Recall Service Bulletin RSB23-180-001

APPLIES TO: This service bulletin applies to certain 2022 through 2024 model year,

NHTSA/TC Id: 23V-156 / TC2023-126

SUBJECT: 3000 and 4000 Emergency Vehicle SeriesTM (EVS) 6th Generation TCM Recalibration

Figure 1. Current Software Level Example in Allison DOC

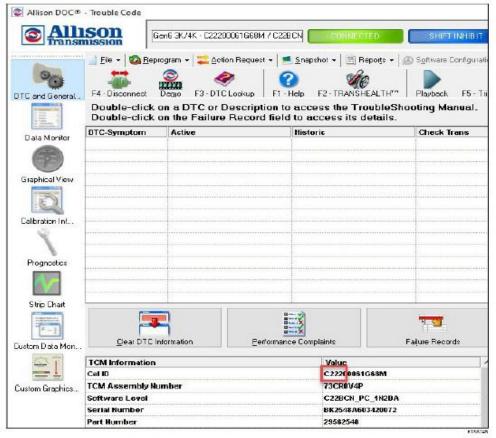
Once a Field Action Authorization Number has been obtained, confirm that the TCM has C221, C222, C223 or C224 software. This can be found by connecting the TCM with Allison DOC®. The DTC and General Info tab will show the Cal ID in the TCM Information section. The first four digits of the Cal ID give the current software level. The software level must be updated if the first four digits of the Cal ID are any of the following: C221, C222, C223 or C224.

If the vehicle is in the affected population, then update software level from C221, C222, C223, or C224 to C232 or later by programming based on the TCM serial number in TCM ReflashTM. To receive the latest software level, it is necessary to check the box labeled "Download Latest Calibration" on the Add screen in TCM Reflash (refer to Figure 2). After programming is complete, use Allison DOC to verify that the second through fourth digits of the Cal ID are 232 or later (refer to Figure 3).
